## WCWRPC Review

# Chippewa Falls/Eau Claire Urban Sewer Service Area Plan Request for Type IV Amendment

**Project:** Oakwood Business Park Lot 4  
**Requesting Entity:** City of Eau Claire  
**Request Received:** received by WCWRPC on 1/9/12  
**Review Date:** January 10, 2012

LOCATION MAP

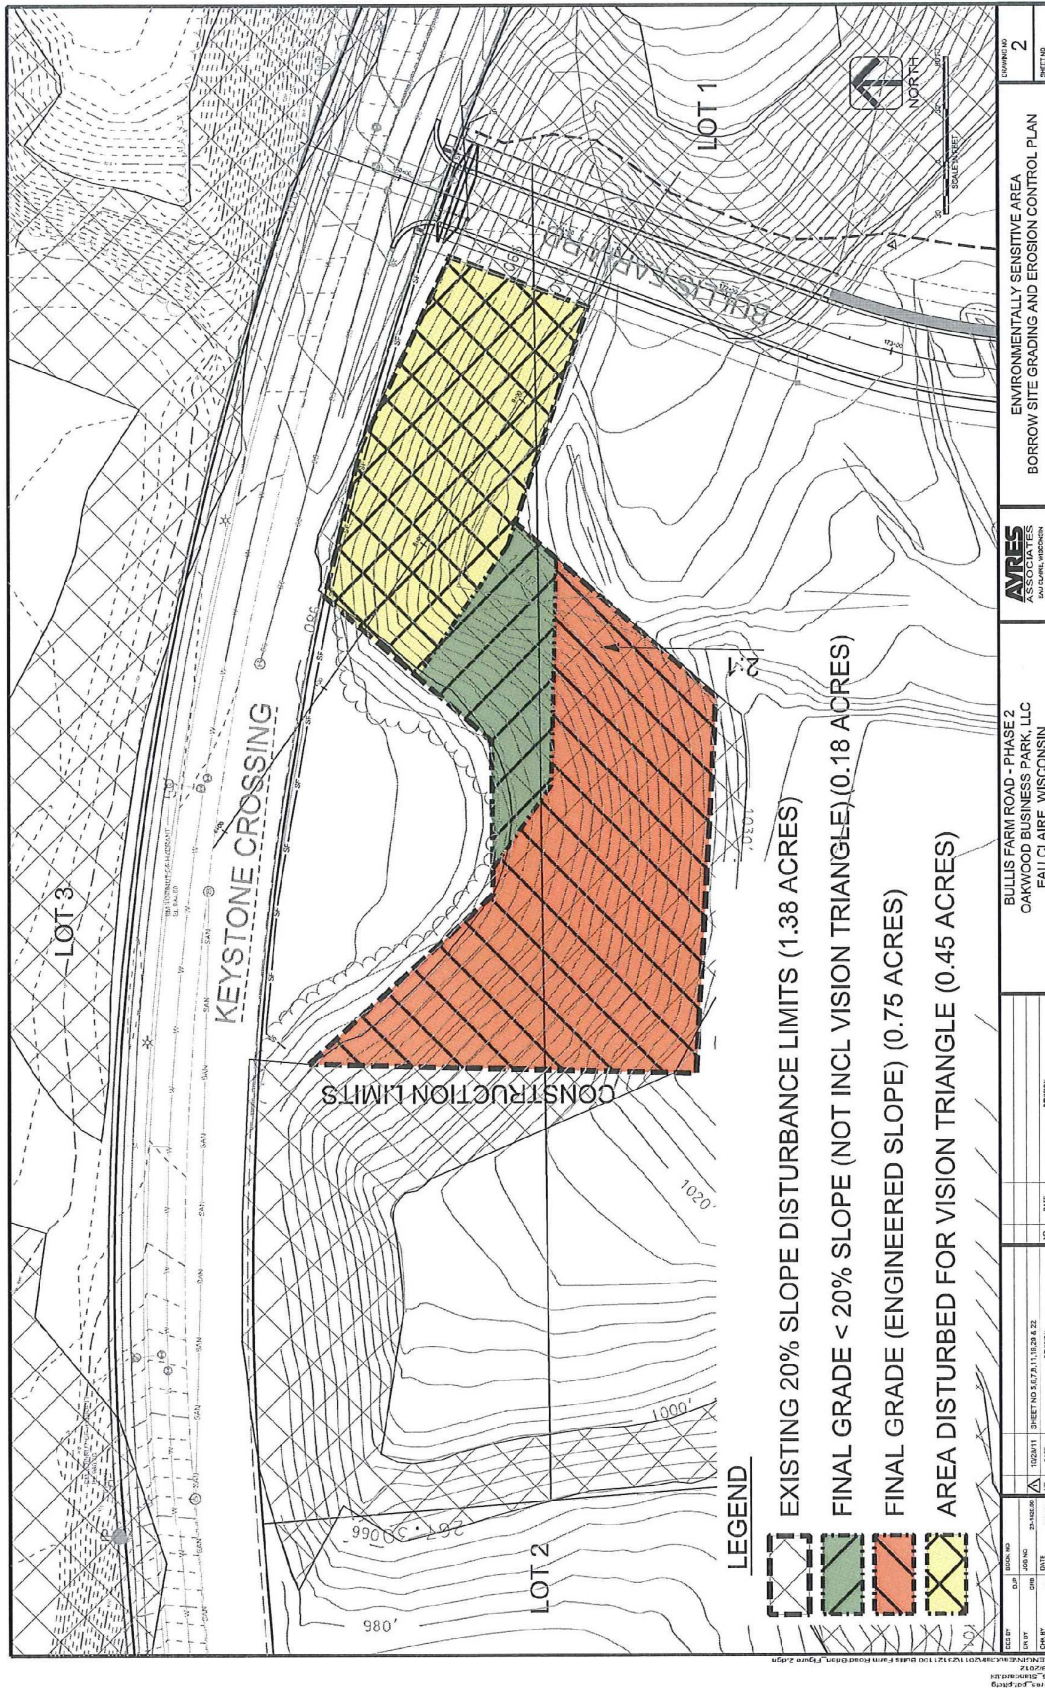
Significant development has already occurred or is proposed for the general area, including commercial-retail, commercial-office, and multi-family housing. Considerable grading for Bullis Farm Road immediately adjacent to the site amendment area has already been completed.

The specific use for the 0.93-acre developable lot has not yet been proposed, though commercial-office or similar use is anticipated. As the previous map shows, the proposed project would encroach upon steep slopes. The grading to be performed as part of this amendment cuts into the hillside, but leaves the top of the hill intact.
